Office Action Summary

10/696,463

DETAILED ACTION

FIG. 3E

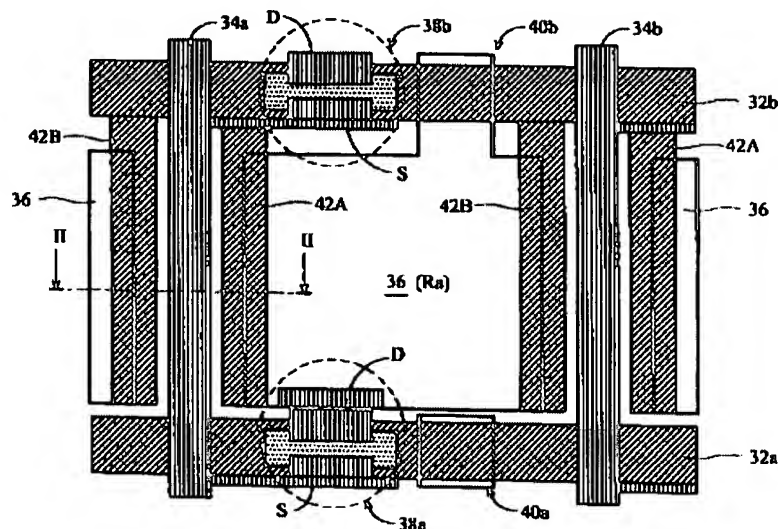
Newly added limitations as to "... overlaps across the source electrode of the thin film transistor of the adjacent pixel area." is considered misleading. Please reference Applicant's Figure 3E of the elected invention. 42A overlaps the extension portion of data line 34a that runs from 34a to the source of the TFT, 38b, at S. This is considered to be NOT the adjacent pixel area to the left of 34a at 42B and NOT above 32b.

Also, the first shielding layer does not overlap any source electrode.

Examiner understands what Applicant apparently wants to claim regarding 38b driving an adjacent sub-pixel, but the present claim limitations are still way too broad and misleading.

For examination purposes, "of the adjacent pixel area" will be considered to limit to - - any area adjacent the central portion of the pixel area - -. In other words, the peripheral area surrounded by 34a, 34b, 32a, and 32b.

Also, for examination purposes the shielding layer will be considered to overlap the extension portion connecting 34a to the source electrode at S, per Applicant's elected species, Figure 3E.

FIG. 3E

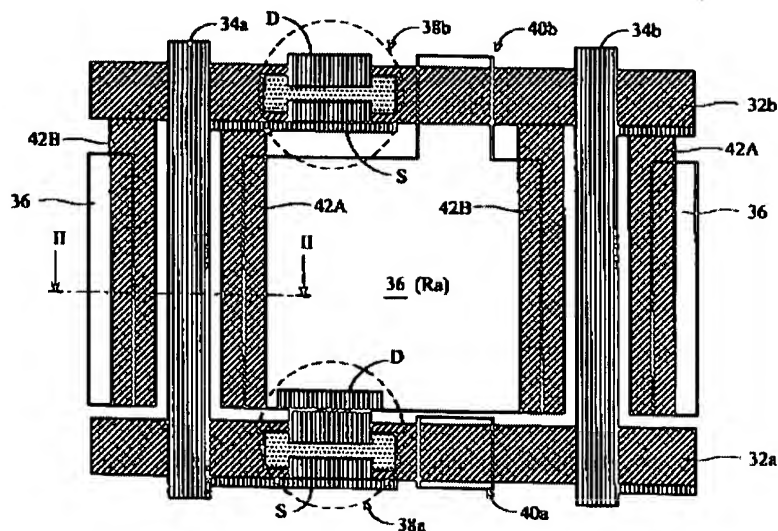
- (1) It is respectfully pointed out that newly added limitations as to "... overlaps across the source electrode of the thin film transistor of the adjacent pixel area." is considered misleading. Please reference Applicant's Figure 3E of the elected invention. 42A overlaps the extension portion of data line 34a that runs from 34a to the source of the TFT, 38b, at S. This is considered to be NOT the adjacent pixel area to the left of 34a at 42B and NOT above 32b.

Also, the first shielding layer does not overlap any source electrode.

Examiner understands what Applicant apparently wants to claim regarding 38b driving an adjacent sub-pixel, but the present claim limitations are still way too broad and misleading.

For examination purposes, "of the adjacent pixel area" will be considered to limit to - - any area adjacent the central portion of the pixel area - -. In other words, the peripheral area surrounded by 34a, 34b, 32a, and 32b.

Also, for examination purposes the shielding layer will be considered to overlap the extension portion connecting 34a to the source electrode at S, per Applicant's elected species, Figure 3E.
